Name The Career Academy - Bid Package 3  
Owner SCC  
Bids Due 6/5/2014 Time 2:00 p.m.

Number 2

ADDENDUM #2 – PART 1  
Bid Package 3

PROJECT:	LPS-SCC Career Academy	PROJECT NO.	L13414
FROM:	BVH Architects	DATE:	05/29/2014
TO:	Hampton Commercial Construction, Inc.	ADDENDUM	#2

## P7/A6.1 DETAIL

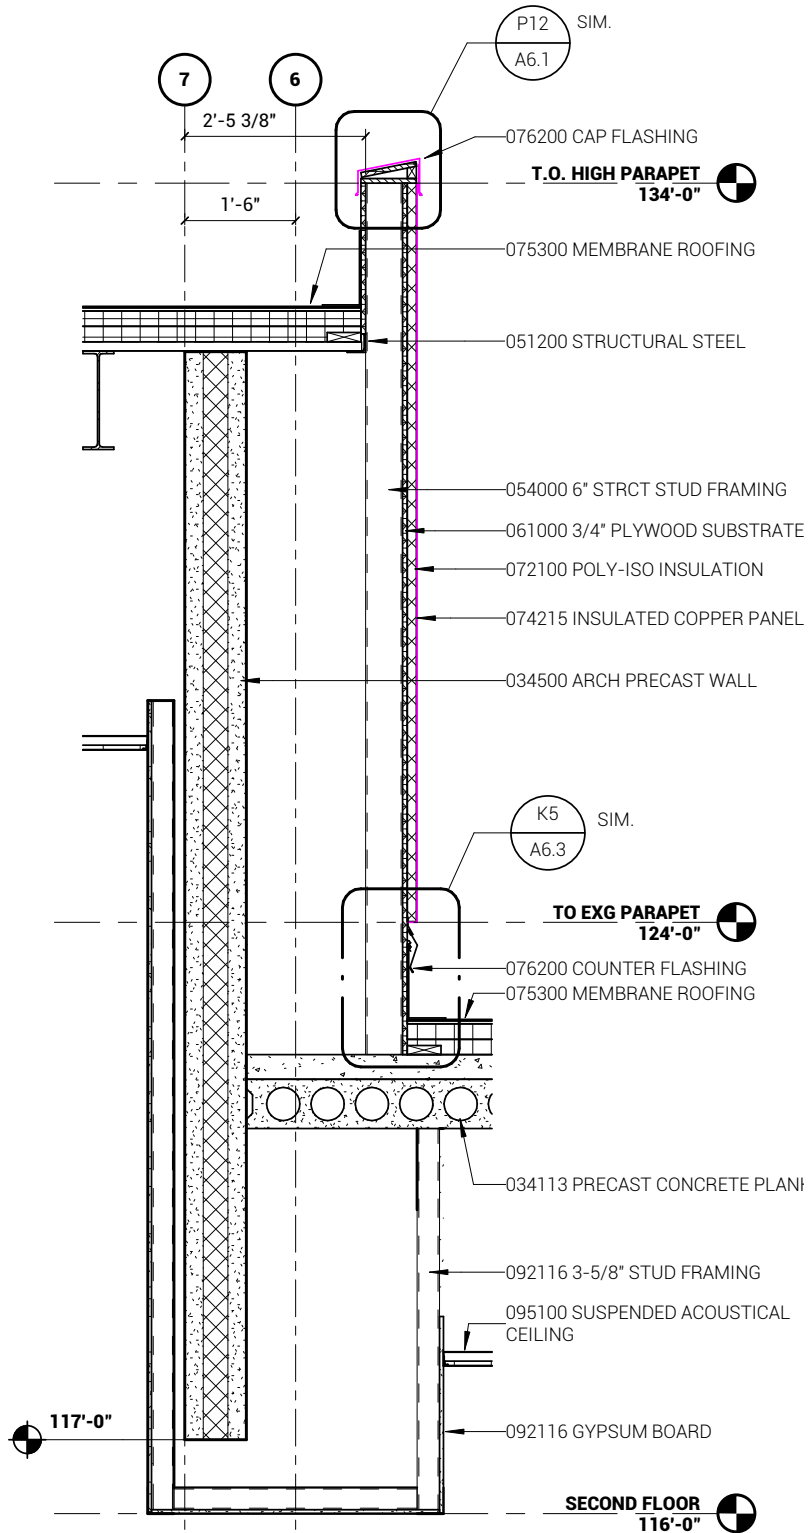
- b. Provide 075300 30"x30" WALKWAY PADS AT EA GUTTER along Gridline J eave line.
  - c. Add Attached Detail P7/A6.1 at roof curbs along Gridlines XA-6, L-6, and H-2.

## E1/A6.3 DETAIL

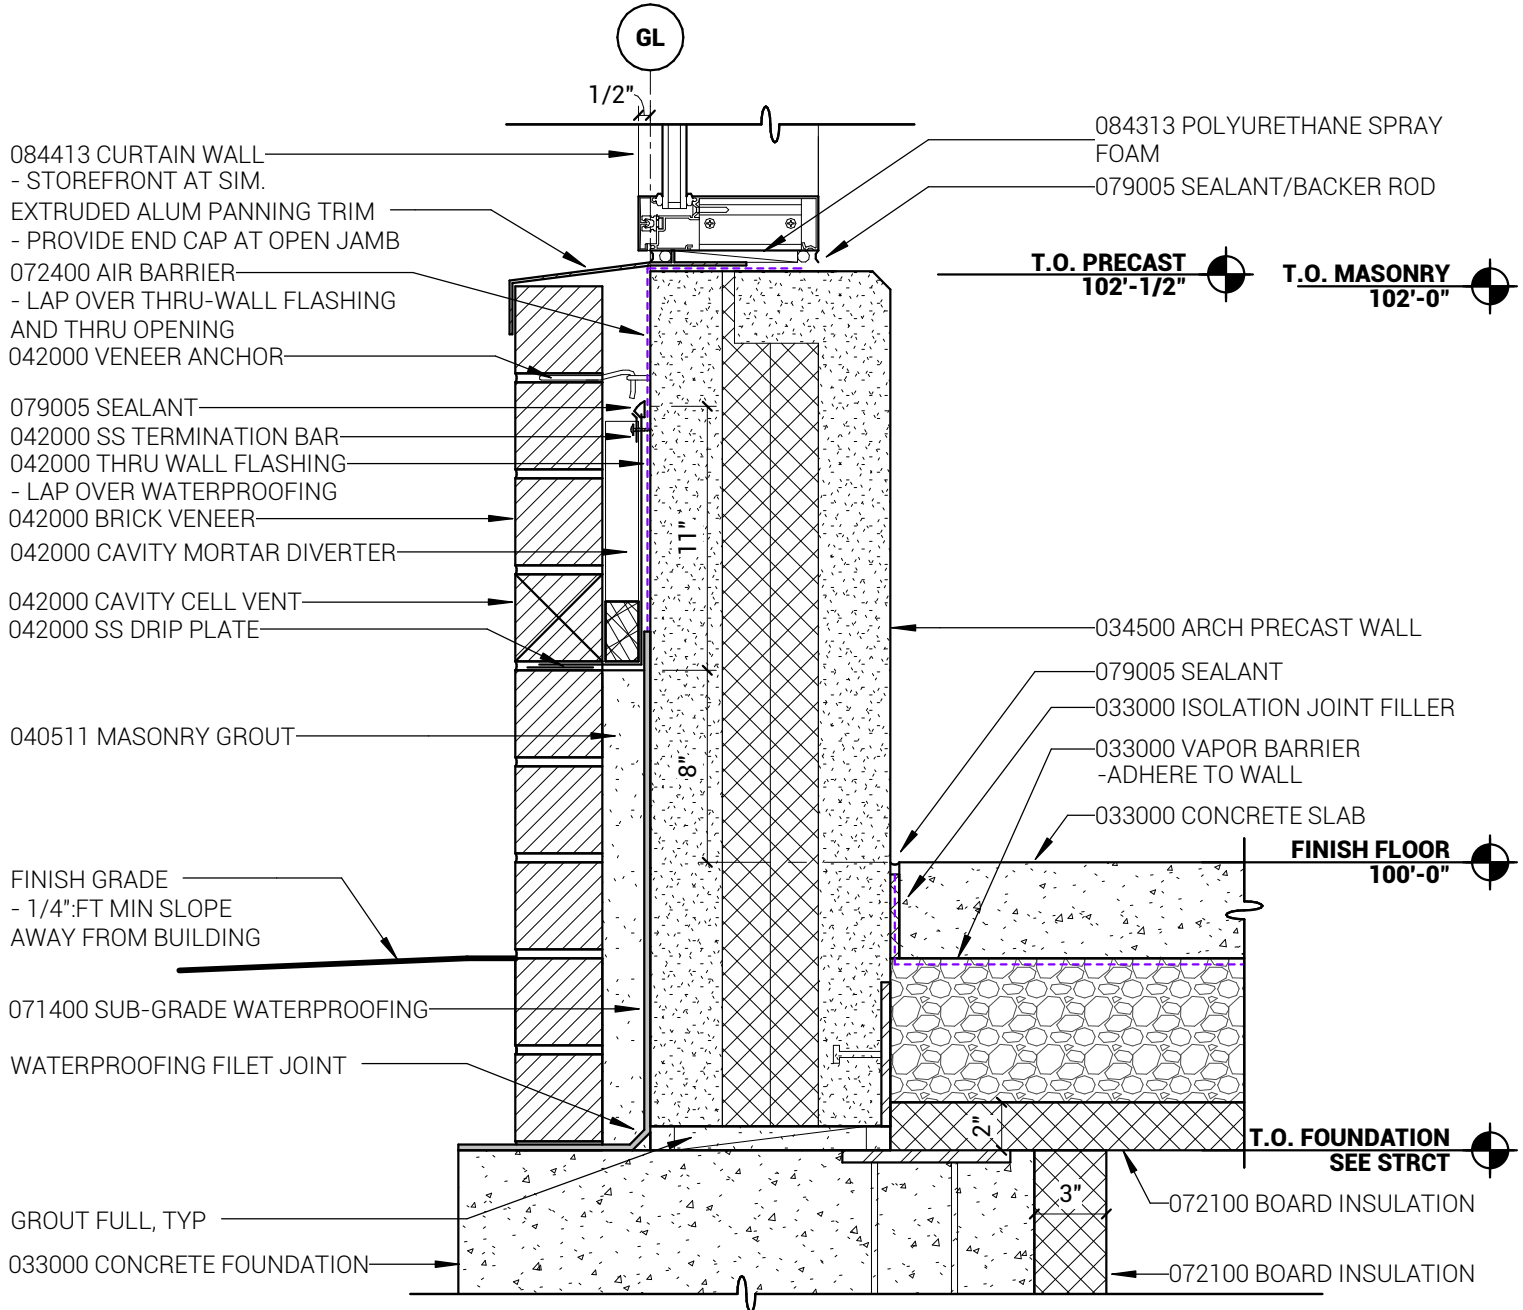
- 12. Sheet A6.3 DETAILS
  - a. 1/A6.3 DETAIL: Replace with the attached Detail E1/A6.3.
  - b. R10/A6.3 DETAIL: Replace '092116 GLASS MAT FACED SHEATHING' with '061000 WALL SHEATHING' at backside of parapets.

## J11/A6.4 DETAIL

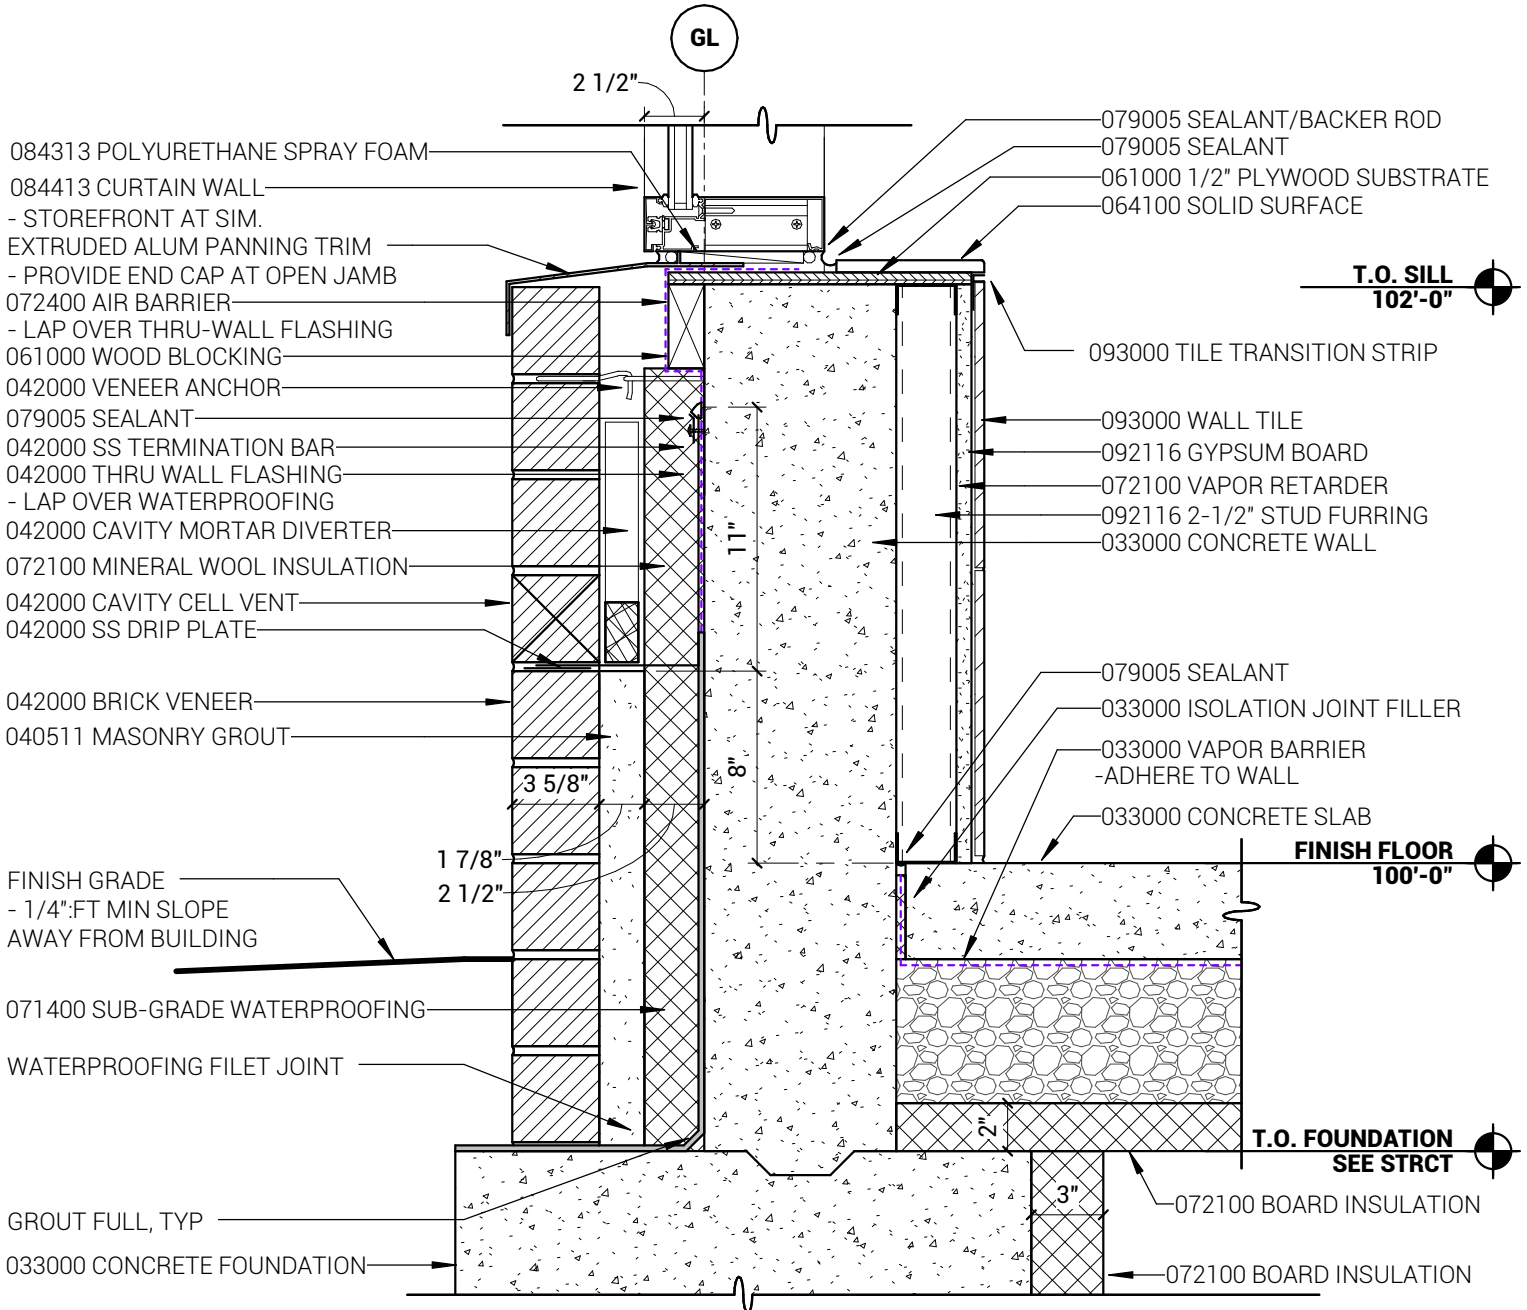
- 8. Sheet A5.5 WALL SECTIONS
  - a. A7/A5.5 WALL SECTION: Reference wall base callout detail to J11/A6.4. Wall assembly shall be 034500 ARCH PRECAST WALL, 072510 AIR BARRIER, 042000 BRICK VENEER. Sill Height shall be 102'-1/2".

- 13. Sheet A6.4 DETAILS
  - a. J11/A6.4 DETAIL: Replace with the attached Detail J11/A6.4.
  - b. Add attached DETAIL J7/A6.4.
  - c. A1/A6.4 DETAIL: Add an additional eave flashing that laps into the gutter. Revise the Gutter width to 6". Add note for all Downspout spacing to 12'-0" CC Max.

## J7/A6.4 DETAIL

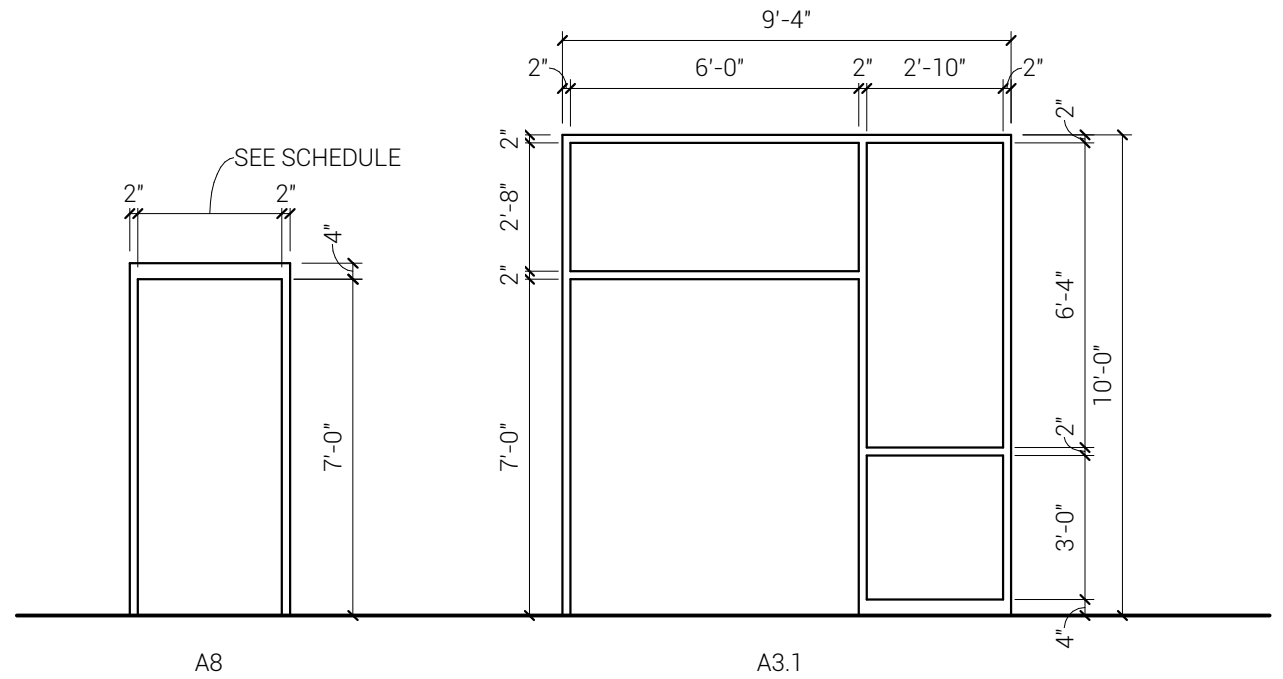
- b. A19/A5.5 WALL SECTION: Reference wall base callout detail to J7/A6.4. Wall assembly shall be 033000 CIP CONCRETE WALL, 072510 AIR BARRIER, 072100 2-1/2" MINERAL WOOL INSULATION, 042000 BRICK VENEER. Sill Height shall be 102'-0".

**J16/A7.1 ALUMINUM STOREFRONT FRAME ELEVATIONS - ADD #2 BP #3**

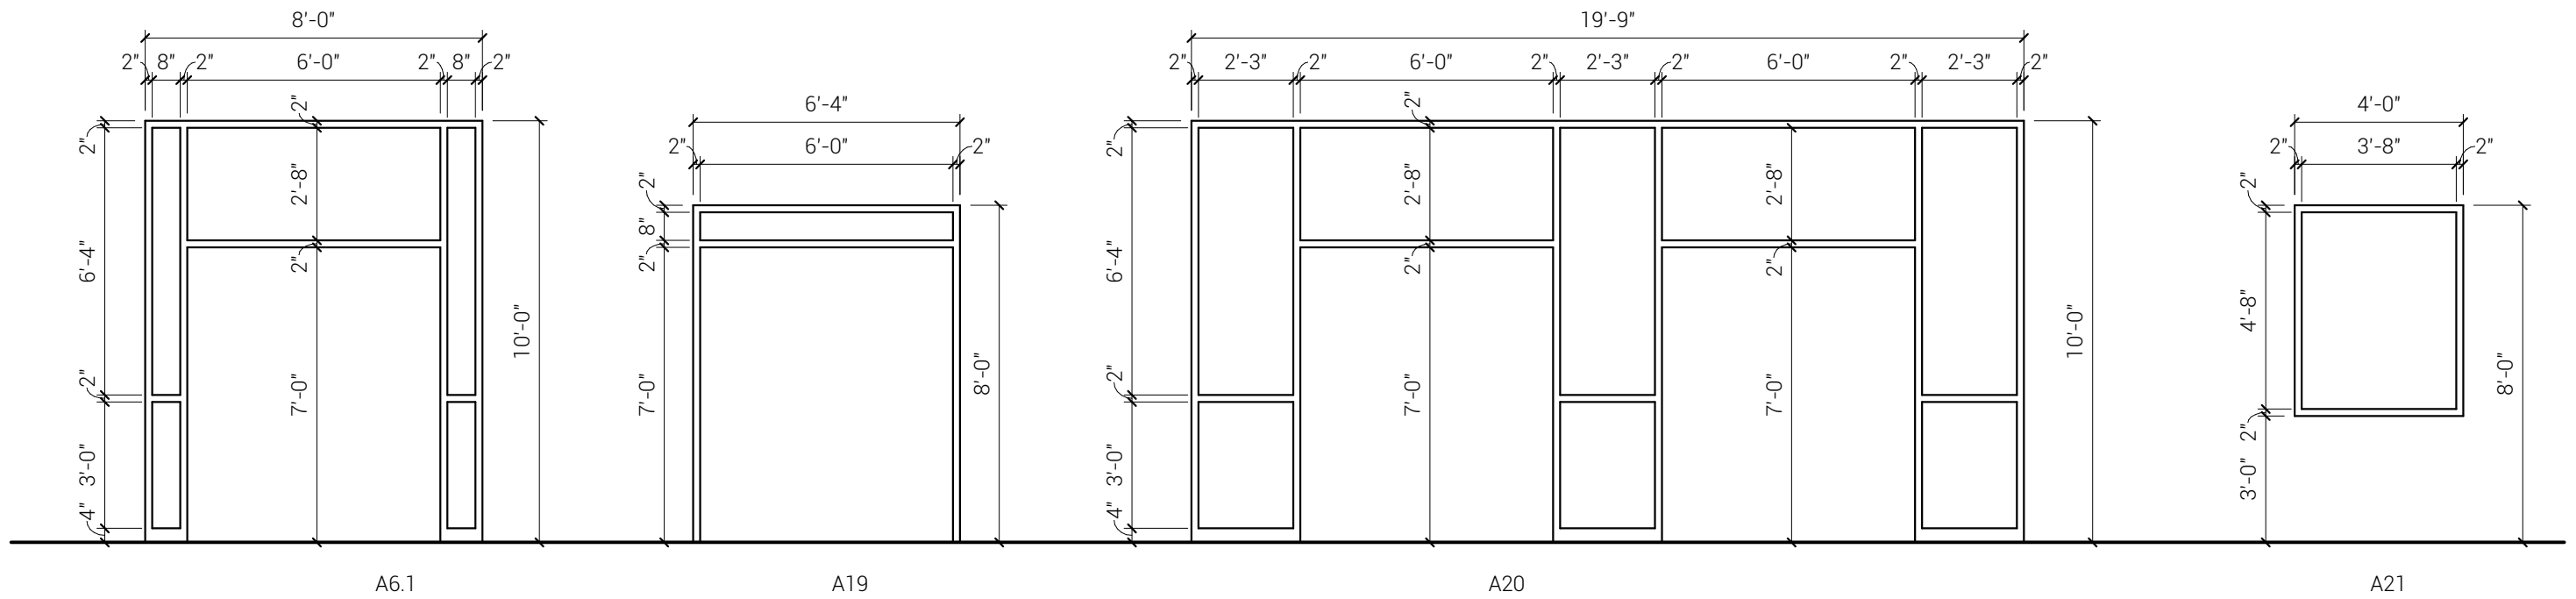
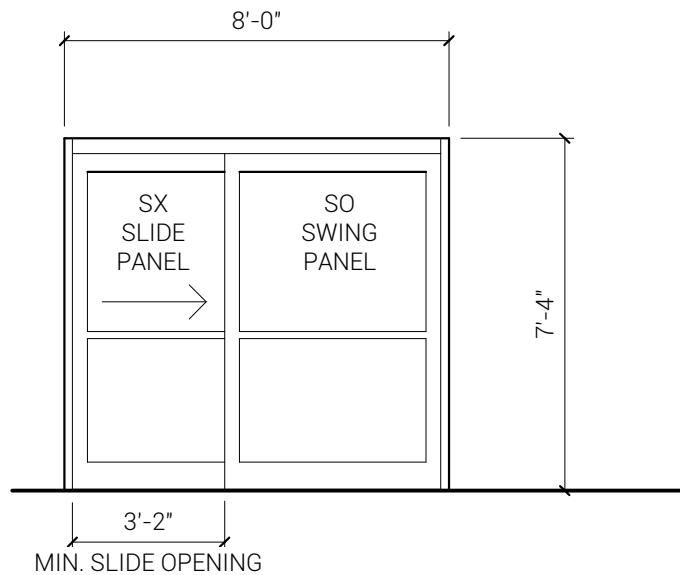
- ii. Frame Type A-1 shall be changed to Type A8
  - iii. Frame Type A-2 shall be changed to Type A3.1. See the attached Drawing J16/A7.1 ALUMINUM STOREFRONT FRAME ELEVATIONS for the revised frame elevation of Frame Type A3.1.

- iv. See the attached Drawing J16 – ALUMINUM STOREFRONT FRAME ELEVATIONS for the frame elevations of the new Frame Types A6.1, A19, A20, and A21.
- c. See the attached Drawing S20/A7.1 – ALUMINUM SLIDING DOOR ELEVATION for the revised frame and door elevation of Frame Type AS-1.
